ADDENDUM NO. 1

PROJECT NO. TMUA-W 23-09 TO-01 – SPAVINAW PUMP HOUSE

**ADDENDUM NO. 1  
TO  
PROJECT NO. TMUA-W 23-09 TO-01 – SPAVINAW PUMP HOUSE**

**ADDENDUM NO. 01**  
**Spavinaw Pump House**  
**TMUA-W 23-09 TO-01**  
January 8, 2025

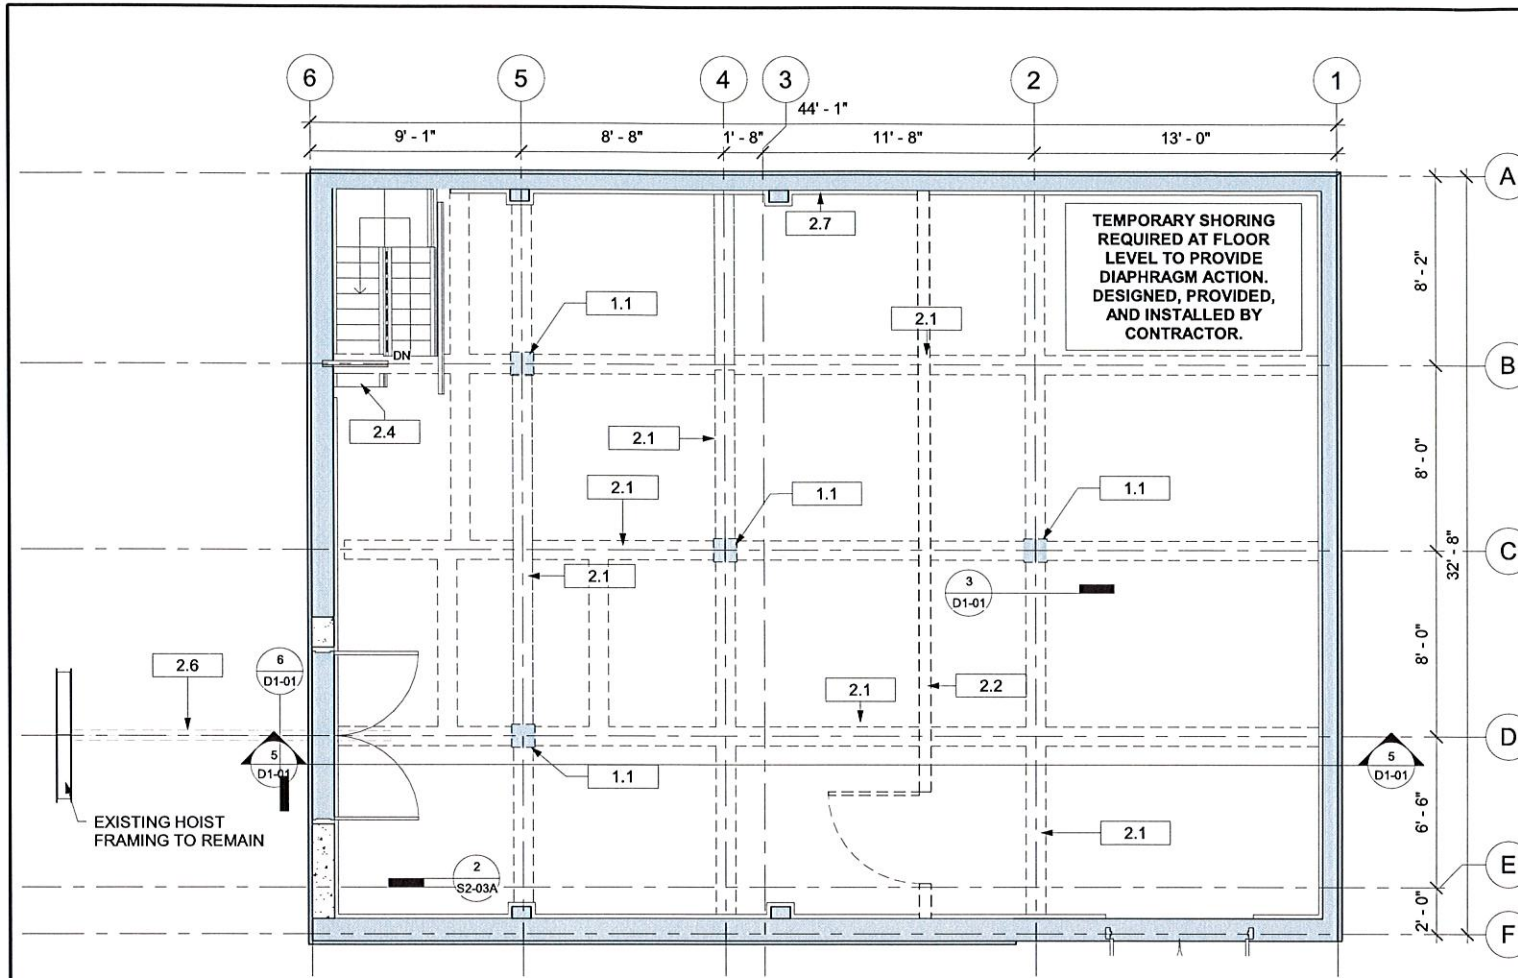
2. G1-01
  - i. General Notes: Added note 17. E
  - ii. Project Description Notes: Revised note 6. B to remove painting of new valve
  - iii. Add Alternate #2 Pay Item Notes: Revised note to remove painting of new valve.
3. D1-01
  - i. Added beam to be removed at the roof between gridlines 1 and 2.
  - ii. Added patch detail for existing roof beam flange.
  - iii. Added beam to be removed at the roof between gridlines 4 and 5.

PLAN SCALE:	DRAWN	HTS	APPROVED
1/4" = 1'-0"	DESIGNED	SAL	
	SURVEY		
PROFILE SCALE:	PROJ. MGR.	1/1/25	
	LEAD ENGR.	1/25	
HORIZONTAL:	FIELD MGR.		
VERTICAL:			
FILE:	DRAWING:		
ATLAS PAGE NO.:	10629	DATE:	11/15/2024
SHEET NAME:	<b>FRAMING PLANS</b>	PAGE NO.:	11 OF 24
		SHEET NO.:	<b>S1-02</b>

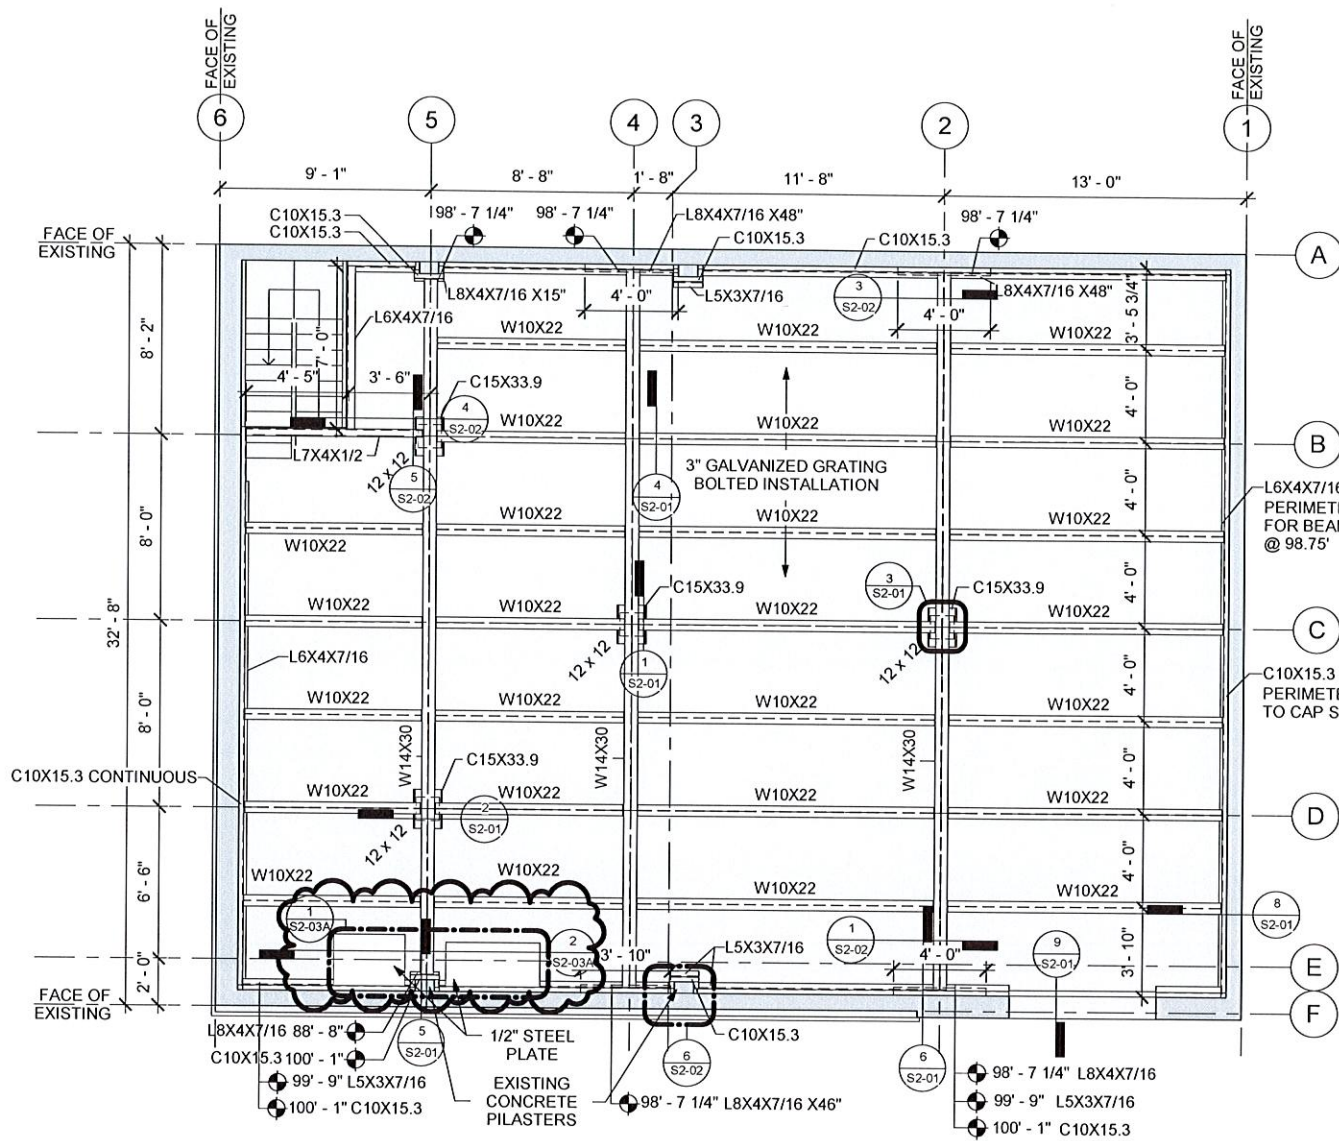
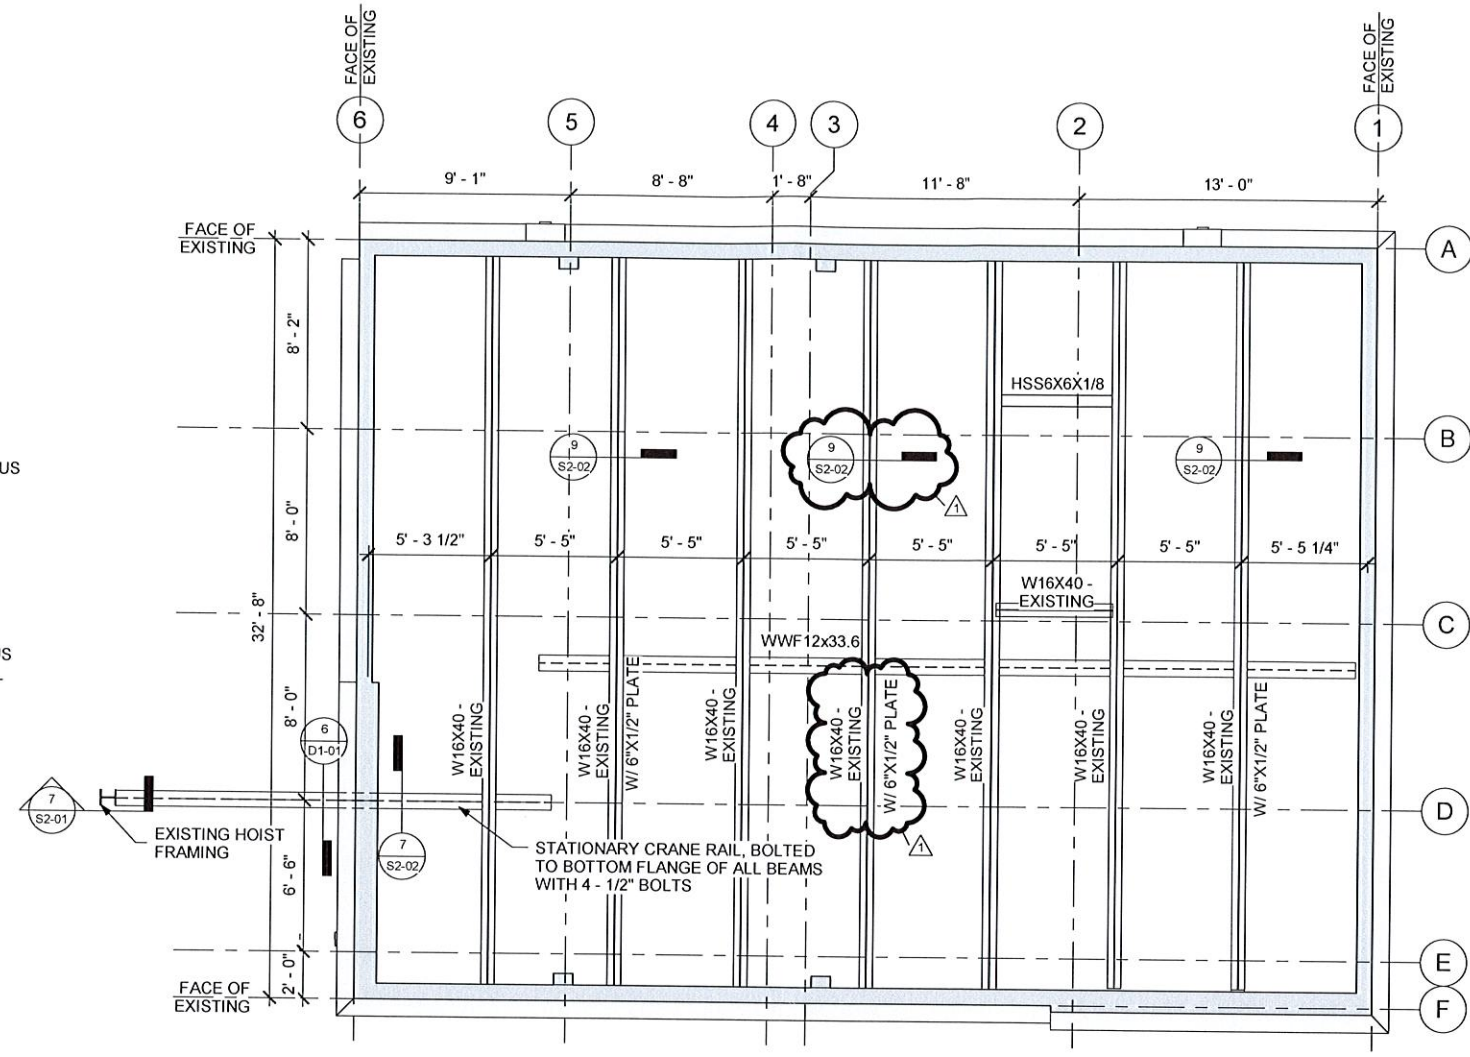
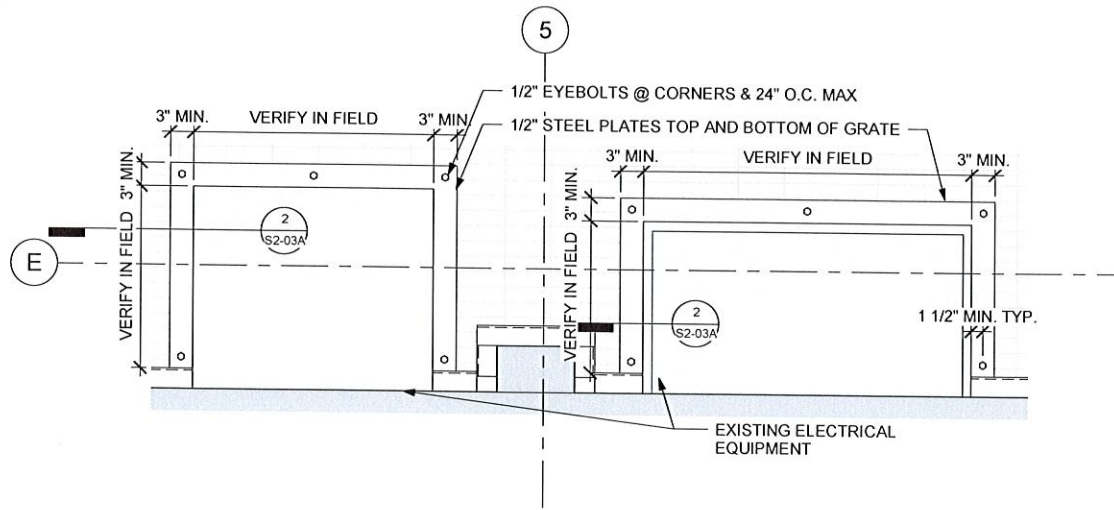
4. S1-02
  - i. Detail 1
    - i. Added references to new details 1 and 2 Sheet S2-03A.
  - ii. Detail 2
    - ii. Moved location of crane support beam with new 6" x 1/2" plate to the north one beam to the existing beam approximately 2'-7" south of gridline 3.

- Q8: *On drawing S1-02 there are three (3) existing beams that are not marked for demolition/removal. It appears these will interfere with the movement of the new crane. Please confirm the status of these beams and provide additional guidance.*  
A8: This has been addressed in Addendum 1.

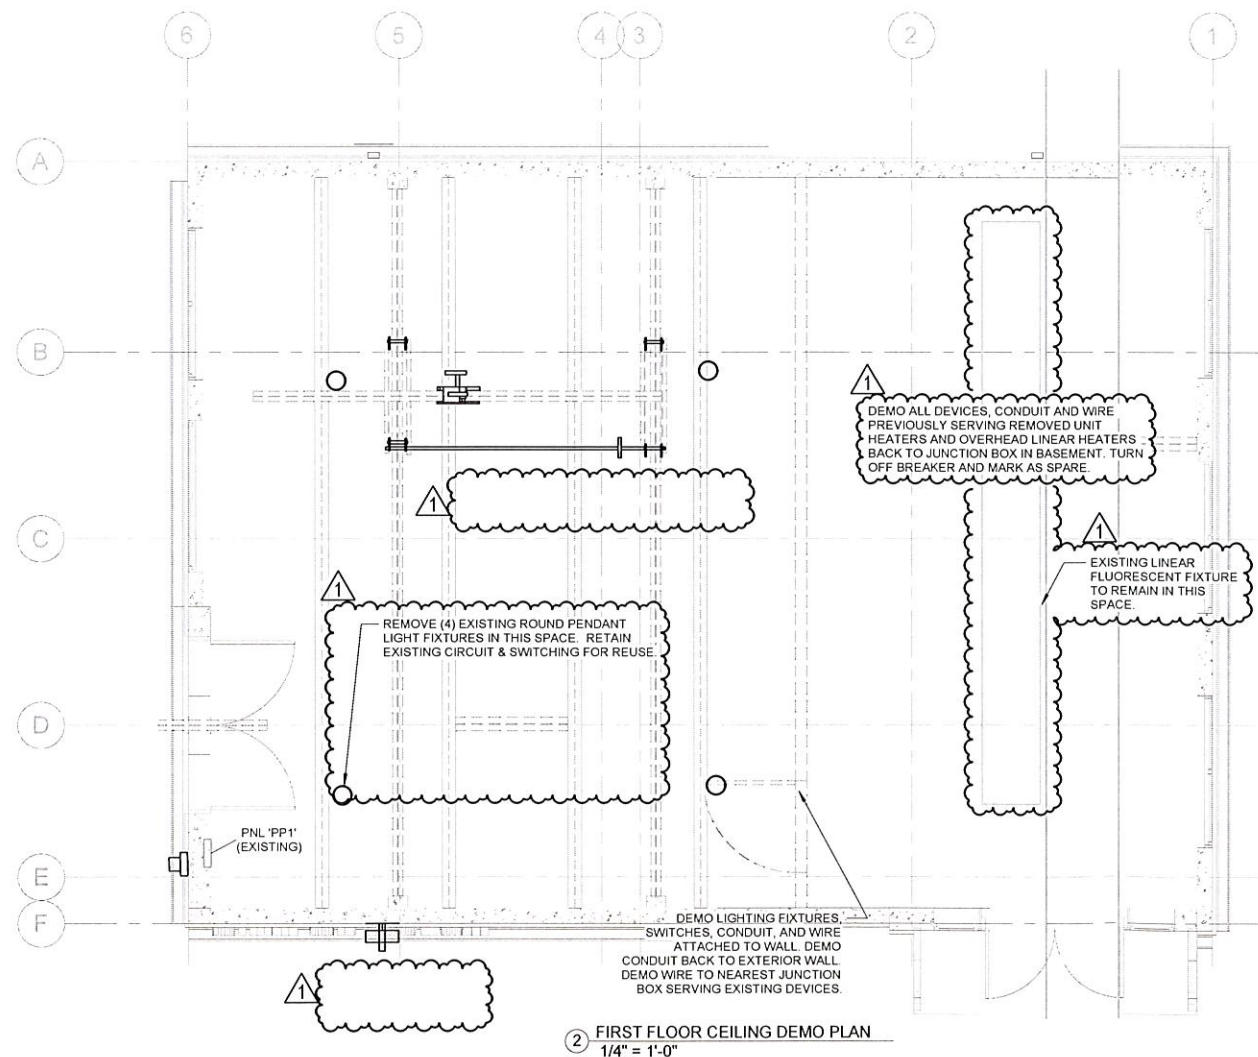
5. S2-03A
  - i. Added details 1 and 2 showing plate support for MCC units and transformer.
6. E0-01
  - i. Updated general note 9 to include laminated and O&M circuit directory.

- ii. Updated project scope notes to reflect changes.
  - iii. Added Power Interruption Note for outage clarification.
7. ED1-01
  - i. Added boxed note about skim and patch concrete walls.

- PROVIDE A COMPLETE TYPED PANELBOARD IDENTIFICATION SCHEDULE AND PANELBOARD NAMEPLATE FOR ALL PANELS. PROVIDE A LAMINATED DIRECTORY FOR THE SITE AND AN ELECTRONIC COPY ON A FLASH DRIVE AS PART OF FINAL O&M SUBMISSION.

DESIGN MANAGER	DATE	11/15/2024
PAGE NO.	21 OF 24	
SHEET NO.	ED1-01

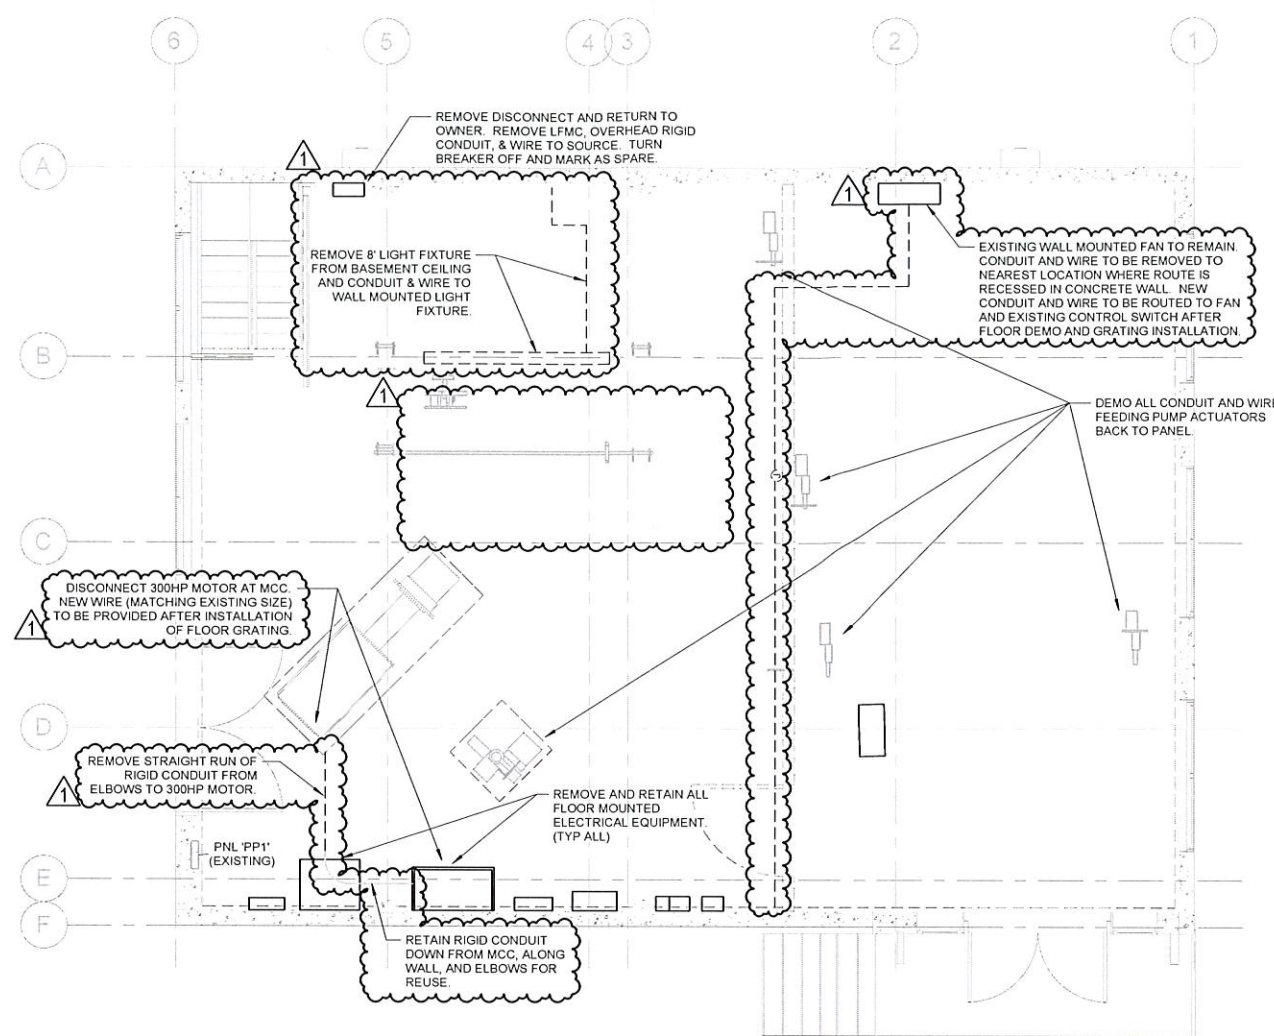
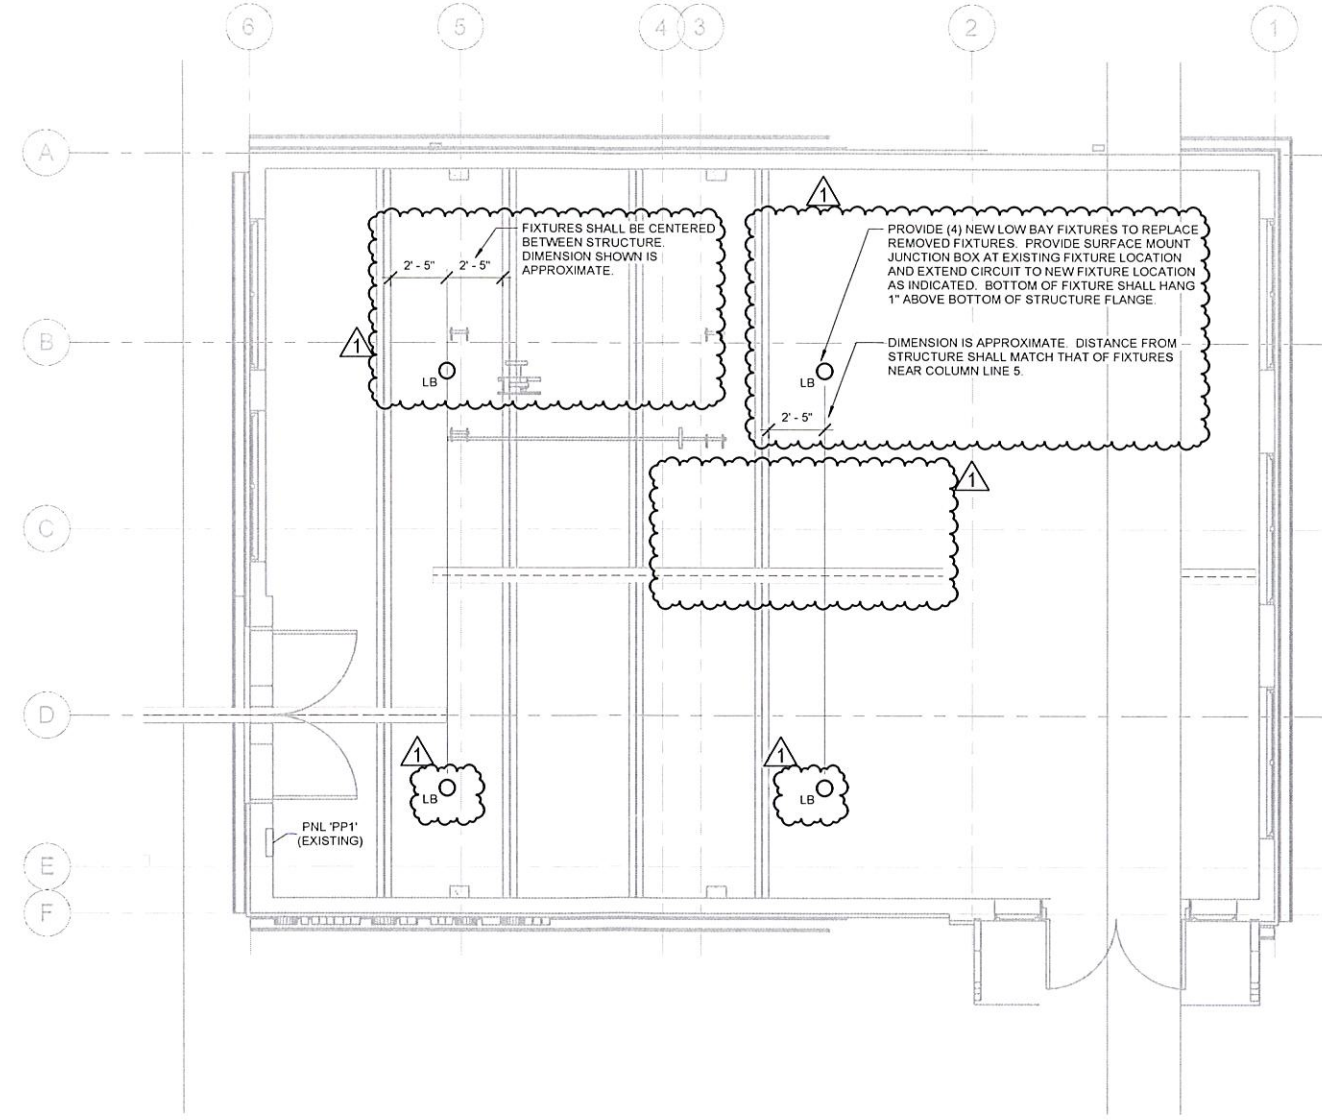
- ii. Detail 1
    - i. Added information about 8' light fixture to be removed.
    - ii. Removed notes no longer relevant.
    - iii. Added note regarding existing wall mounted fan and conduit.

- iv. Modified existing note and added new notes regarding removal of 300HP motor feeder.
  - iii. Detail 2
    - i. Removed notes no longer relevant.

- ii. Added note to remove existing round light fixtures.
    - iii. Added note to retain existing linear light fixture.
8. E1-01
  - i. Added light fixture schedule.

- REMOVE ROUND PENDANT LIGHT FIXTURES IN FIRST FLOOR CEILING. RETAIN LINEAR FLUORESCENT FIXTURE IN FIRST FLOOR CEILING.
- CONTRACTOR SHALL REVIEW ALL MATERIALS, EQUIPMENT, & PARTS THAT HAVE BEEN REMOVED WITH OWNER. SHOULD THE OWNER WANT TO RETAIN ANY MATERIALS THE CONTRACTOR SHALL REMOVE AND DELIVER RETAINED MATERIAL TO THE OWNER ON THE SITE WHERE SO DIRECTED. OTHERWISE ALL DEMOLISHED OR REMOVED MATERIALS SHALL BECOME THE PROPERTY OF THE CONTRACTOR AND SHALL BE REMOVED FROM THE SITE AND BE DISPOSED OF IN A LEGAL MANNER.

SKIM AND PATCH ALL LOCATIONS WHERE DEMOLISHED CONDUIT STUBS OUT FROM CONCRETE WALLS. CONDUIT WITHIN WALLS IS TO BE ABANDONED IN PLACE.

DESIGN MANAGER  
DATE: 11/15/2024  
PAGE NO. 22 OF 24  
SHEET NO. **E1-01**

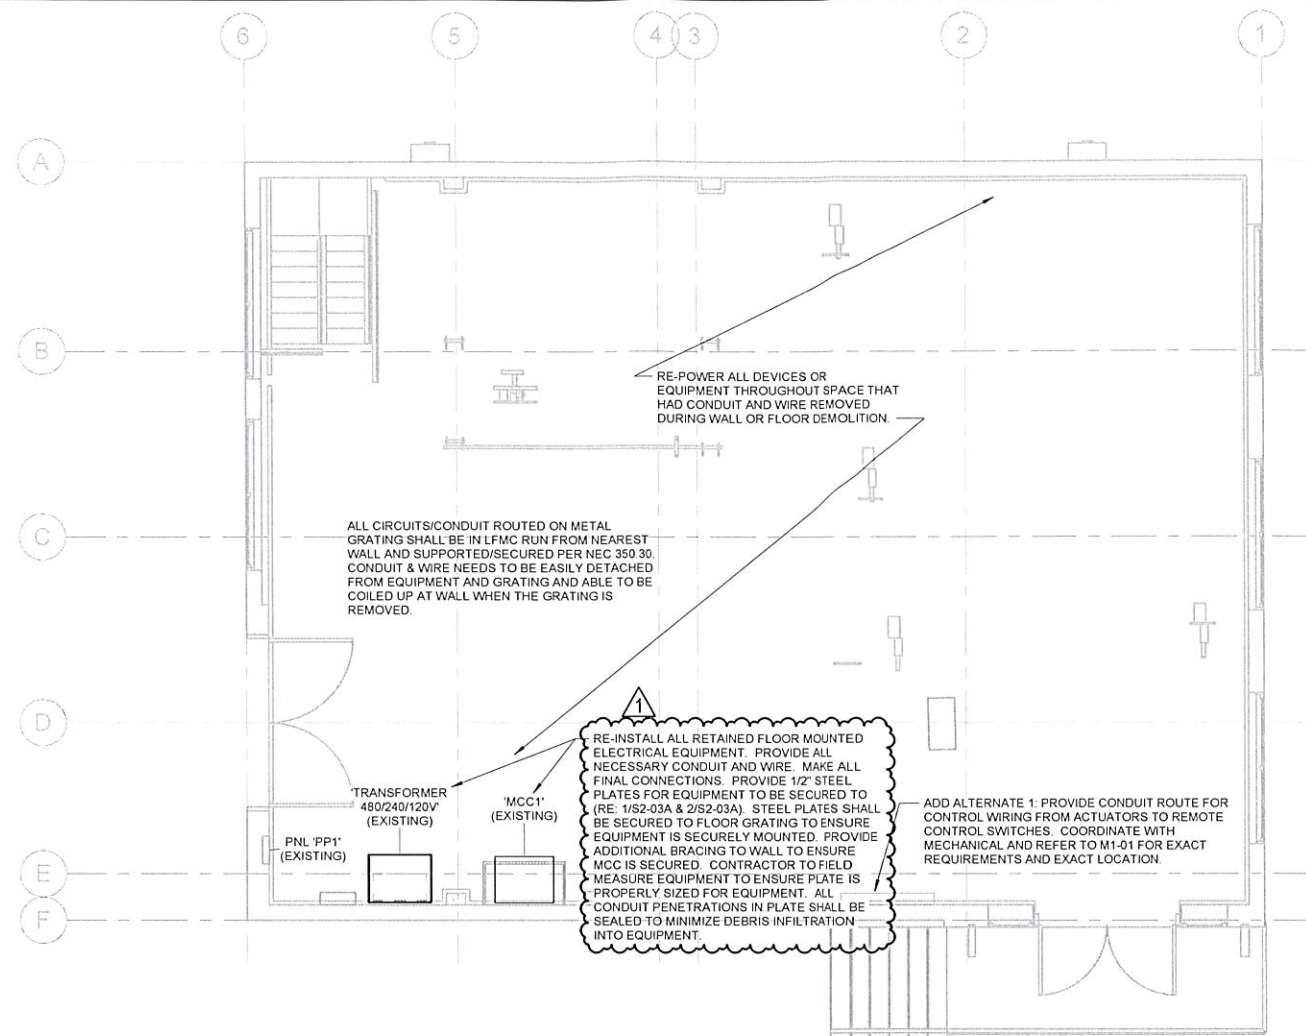
- ii. Added (4) type LB light fixtures and approximate dimensions to plans.
  - iii. Added note about LB light fixture locations and mounting.
  - iv. Removed note for lighting controls.
